NARWEE PARKLANDS CARE COMMUNITY

SSDA SUMMARY OF DESIGN CHANGES FOR DPE

Response to Submission Design Report for the Narwee Parklands Care Community

State Significant Development Application (SSD-45024776)

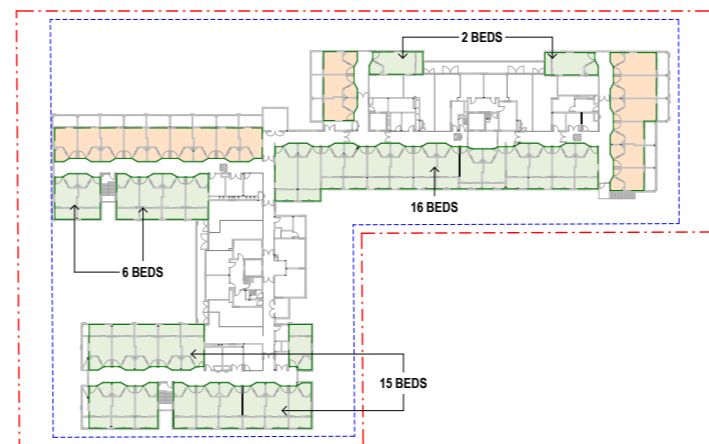
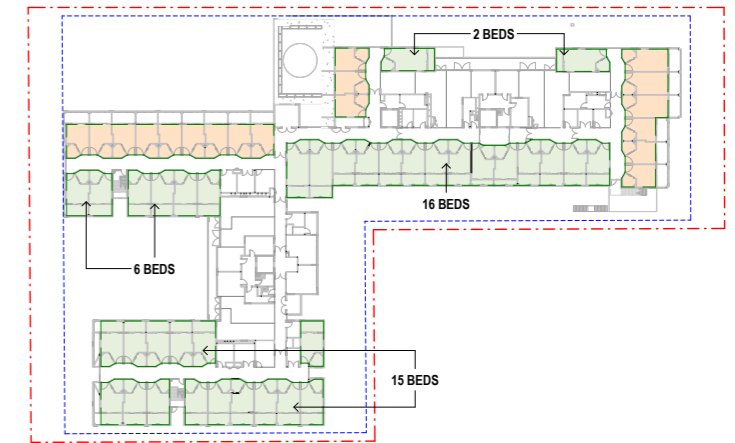
(a) A total of 27 units directly overlook 16.9m of a driveway without a suitable buffer/treatment provided.

(a) The proposed revised design has increased original 400mm wide planter boxes to 900mm wide planter boxes (with 600mm clear planting) along Ground Floor balconies. The widening of planter boxes improve privacy and enhance visual. Native crawling plants have been proposed along the other side of driveways for screening to soften basement ramps concrete upstands and act as a visual green buffer. From the above, the north-western design has been revisited and has improved outlook from Homes and building entry presentation; and improved continuity greenery, from street trees, to crawling plants along driveway upstands, and wider planter boxes along footpath.

In addition, adjacent diagrams demonstrate rooms with green views outlook. 64% of total rooms are equipped with substantial green outlook with the remaining 36% with average green outlook.
